# Wisconsin Department of Transportation

**Proposal #17: 3876-05-71, WISC 2021 035**  
**V Oakfield, CTH D**  
**CTH Y – N. School Street**  
**CTH D**  
**Fond du Lac County**

This is Addendum No. 01, which provides for the following:

**ADDENDUM NO. 01**

Addendum No. 01  
ID 3876-05-71  
Revised Sheet 77  
November 23, 2020

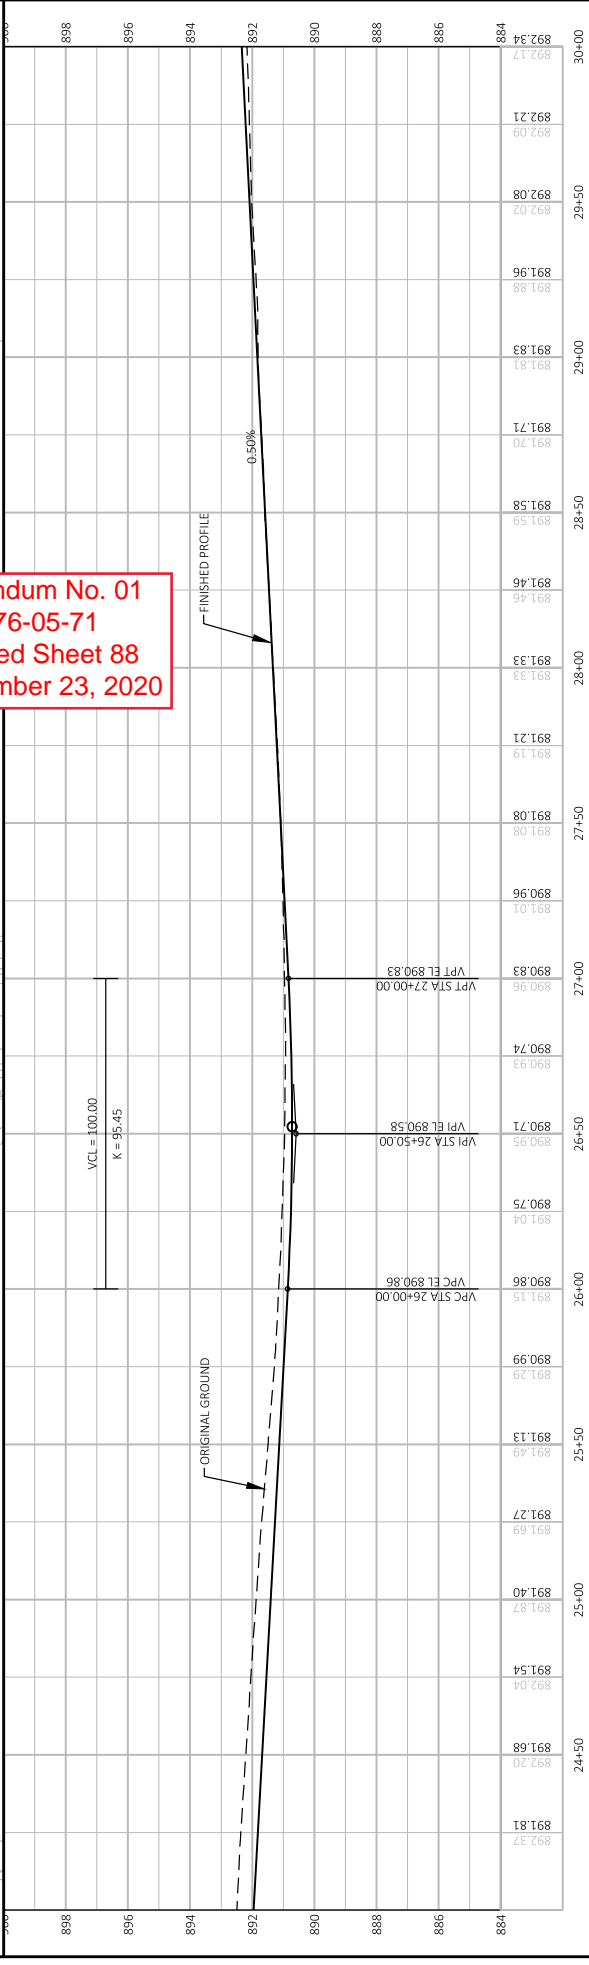
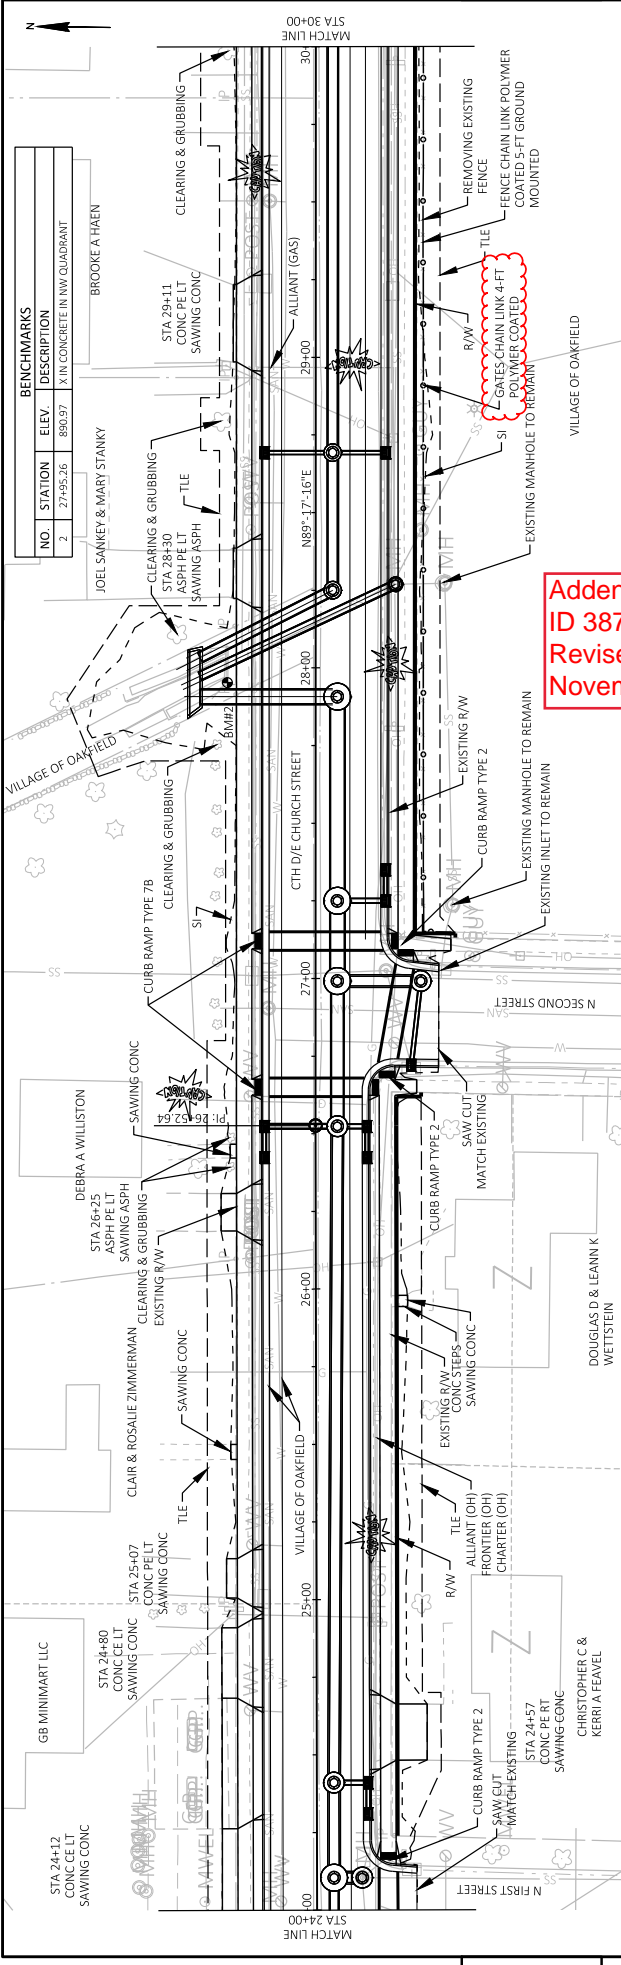
<b>Revised Plan Sheets</b>	
<b>Plan Sheet</b>	<b>Plan Sheet Title (brief description of changes to sheet)</b>
77	Miscellaneous Quantities (changed gate from 3-FT to 4-FT)
88-89	Plan & Profile CTH D (changed notes on gate from 3-FT to 4-FT)

SPV.0060.37  
SPECIAL (37.  
GATES CHAIN  
LINK 4-FT  
POLYMER  
COATED) EACH
